Name of Objectors: Ernest Saeger, Jamie Malin, Bill Hoblitzell, Lee Rimel, Casey Wyse, Mark Luzar, Kathleen Sedillo, Brain Rodine, Fritz Bratschie

Lead Objector: Ernest Saeger, Executive Director, Vail Valley Mountain Trails Alliance
PO Box 3986
Avon, CO 81620

RE: Berlaimont Estates Access Route FEIS and ROD

Berry Creek Trail Counter	April/May 2018
Total Users	2,698
Total Days	36
Avg. Users Per Day	74.9
Max Users In One Day	153
Avg. Weekday Use	66.6
Avg. Weekend Use	96.6

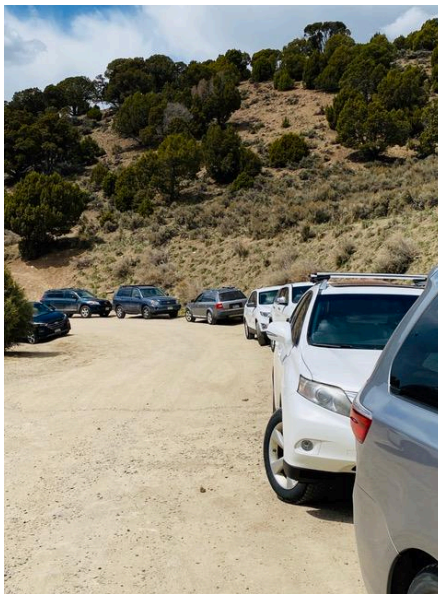
The WRNF Eagle-Holy Cross Ranger District Trails and Wilderness Manager placed a trail counter near the lower FSR774 gate in April/May 2018 for 36 days. Below is the data that was received from this counter:

The USFS employee stated that this data is, “prior to the road opening (before 5/21),” and “I mentioned to the Berlaimont team that these numbers probably accounted for 1/3 of the use that was occurring in the area.” Furthermore, the USFS employee stated, “Also, given the timing (prior to 5/21), there was not any motorized use, and probably limited bike use, too.”
